Road Safety Audit Report

Incorporating
Stage 1 Completion of Preliminary Design.

Proposed Pedestrian footway along the A272 Bolney Road Ansty

Job no	RSA-26-098	Issue no	1	Date	July 2026
Prepared by	JJF	Verified by	ZB	Approved by	JJF
Filename and Path	Fenley/Road Safety Audits/RSA-26/RSA-26-098-1

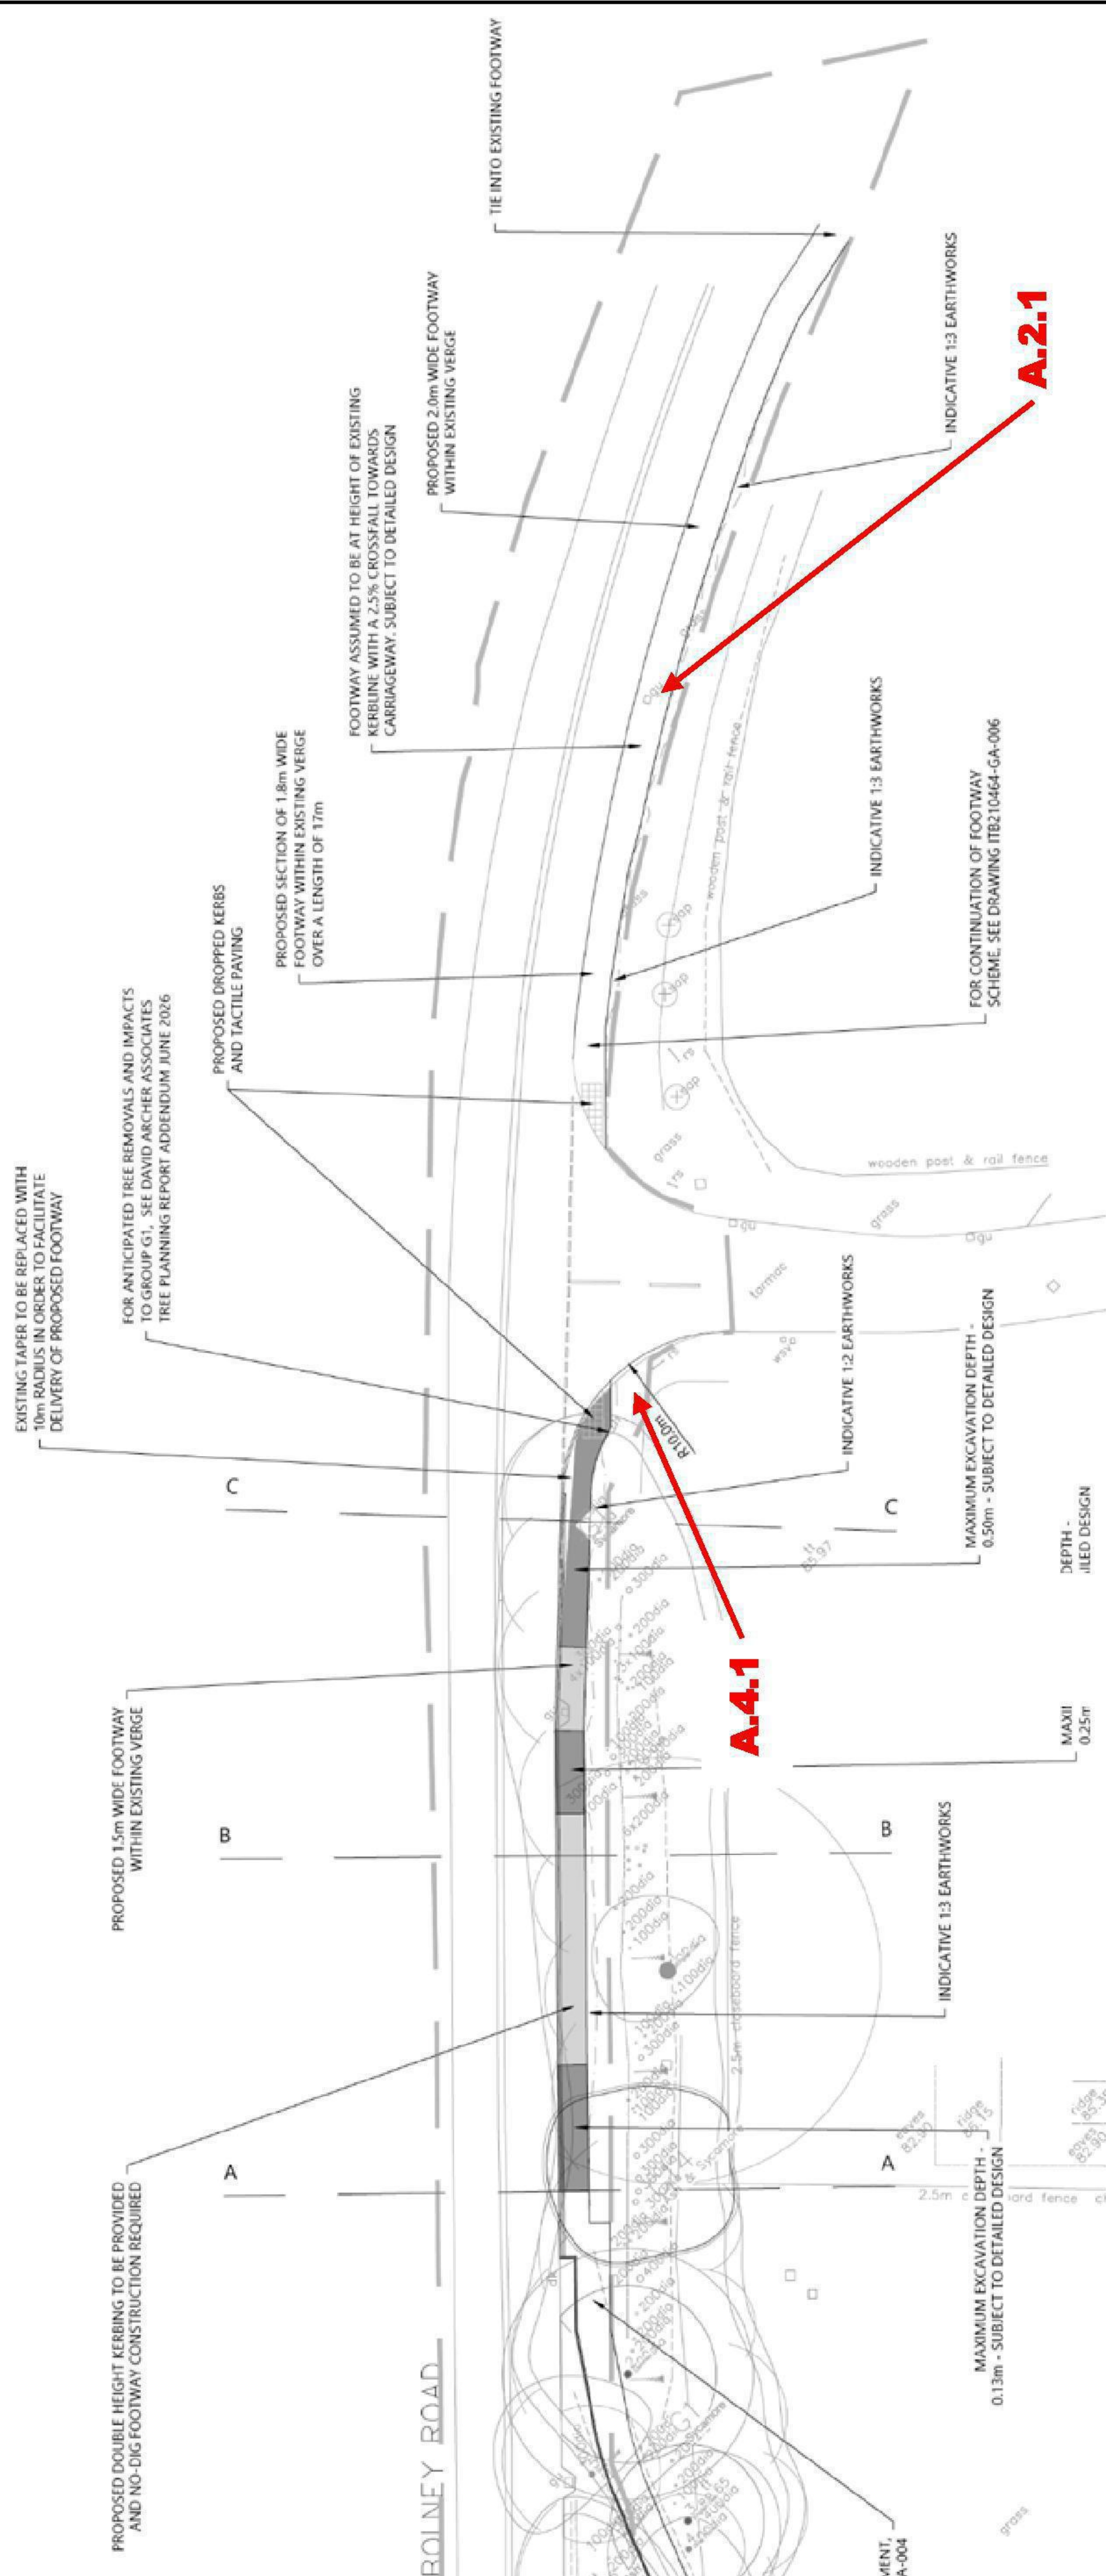
A.4	WALKING, CYCLING AND HORSE RIDING
A.4.1	PROBLEM
Location:	Upton Drive
Summary:	Insufficient intervisibility is achievable between motorists approaching the uncontrolled crossing and pedestrians attempting to cross
Acc Type:	Vehicle / cyclist to pedestrian type collision
The Upton Drive simple priority junction with the A272 Bolney Road is formed with circa 10 metre corner radii and accommodates entry and exit tapers. No pedestrian facilities are provided at the existing junction as no footway is present along the southern side of Bolney Road. A grass verge is present on both sides of the junction with a property boundary hedge situated to the west. The proposals include the provision of a footway along the southern side of Bolney Road with an uncontrolled pedestrian crossing at the existing junction Upton Drive. The scheme drawing illustrates that the proposed uncontrolled crossing is to be inline and therefore the tactile paving is to be 1200mm deep to ensure that pedestrians cannot overstep the tactile warning and enter the carriageway unknowingly. The highway code has been updated in recent years to allow pedestrian priority when crossing side roads. All motorists or cyclists approaching the proposed uncontrolled crossing are therefore obliged to slow / stop when a pedestrian is observed. This works well but is dependent on intervisibility. The Audit Team have concerns that intervisibility between a northbound motorist / cyclist, approaching the give-way line / proposed uncontrolled crossing, and a pedestrian is limited by the presence of the existing boundary hedge. It is understood that northbound traffic will be slowing but a motorist / cyclist may not become aware of a pedestrian entering the carriageway at a safe distance, which could lead to a vehicle / cyclist to pedestrian type collision.

RECOMMENDATION:	
It is recommended that adequate intervisibility is achievable.	
Location Plan:
